**MODIFICATION ASSESSMENT REPORT
TO SYDNEY CENTRAL CITY PLANNING PANEL**

Panel Reference	PPSSCC-12
DA Number	DA/1066/2016/D
LGA	City of Parramatta Council
Proposed Development	Section 4.55(2) modification to approved mixed-use tower development, specifically 1 additional level (no height change, achieved by reduction in floor level heights), 10 fewer hotel rooms, addition of 7 two-storey serviced apartments, relocation of bar from roof levels to mid-tower, relocation of ballroom from base to mid-tower, minor external changes, revised internal layout and revised landscaping. The original application was Nominated Integrated Development under the Water Management Act 2000 and the National Parks and Wildlife Act 1974.
Street Address	2 - 10 Phillip Street, PARRAMATTA NSW 2150 (Lots 1 & 2 DP 986344 and Lot 1 DP 228697)
Applicant	GJC Property Holdings Pty Ltd / Coronation Parramatta Pty Ltd
Owner	GJC Property Holdings Pty Ltd / Coronation Parramatta Pty Ltd
Date of DA lodgement	18 June 2019

The proposal seeks various modifications to development consent DA/1066/2016, construction of a mixed use tower at 2-10 Phillip Street Parramatta, under Section 4.55(2) of the Environmental Planning

Figure 4. Approved Landscaping (left) vs. Proposed Landscaping (Right)

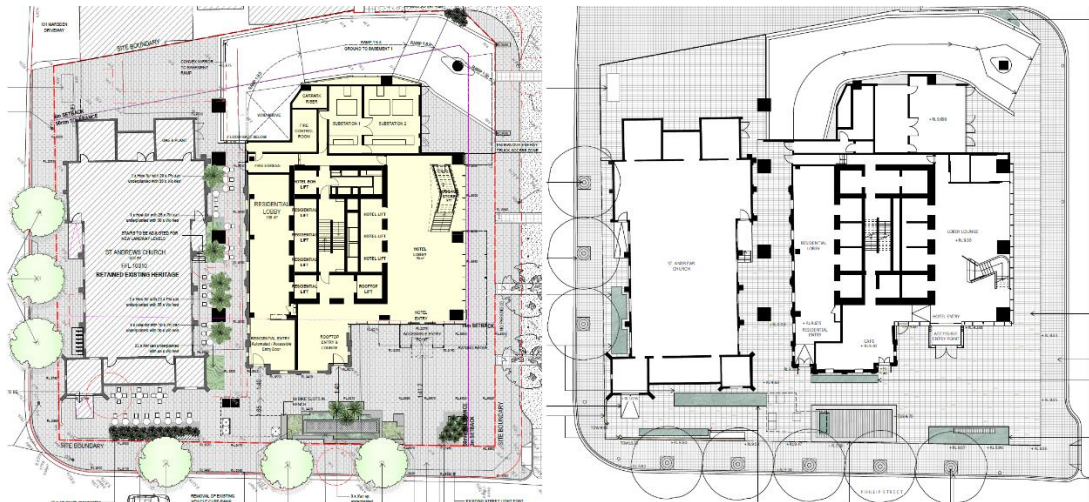
The proposal includes a revised forecourt design. A comparison between the approved forecourt and the proposed forecourt is provided below.

The landscape plan was reviewed by Council's tree and landscape officer and was found to be acceptable subject to the existing conditions.

Figure 6. Approved West Elevation (left) vs. Proposed West Elevation (Right)

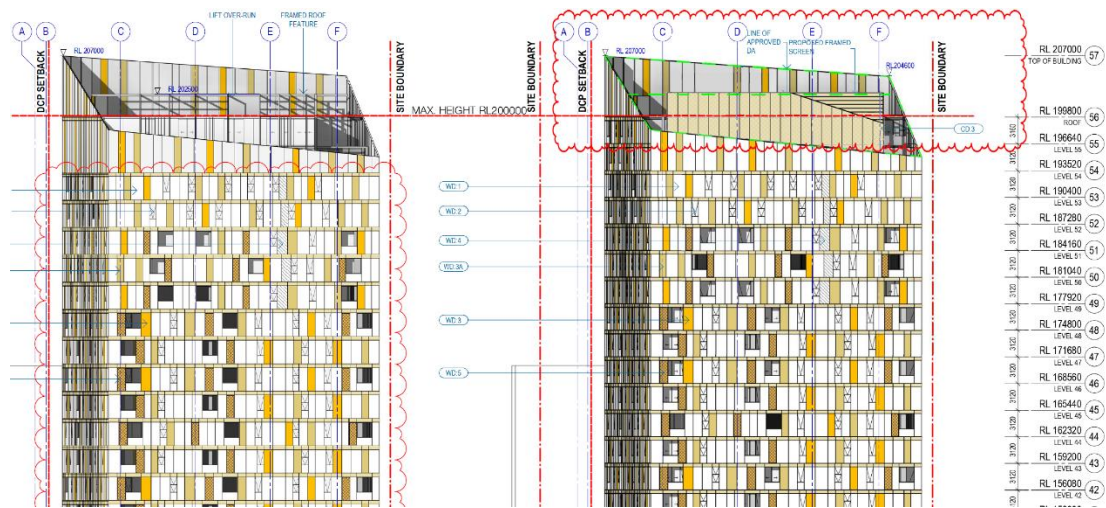
The application includes moving the tower 'cutout' level down 3.1m, revising the hotel entry portal and awning, revising the internal feature stair, and revising the roof plant enclosure.

The design excellence jury found that these changes to the form of the tower to be minor and not sufficient to revoke their design excellence certification. As such the proposal is considered to maintain design excellence as per Clause 7.10 of the PLEP 2011.

The external changes are substantially within the approved envelope and as such will not have further amenity impacts on adjoining or nearby properties.
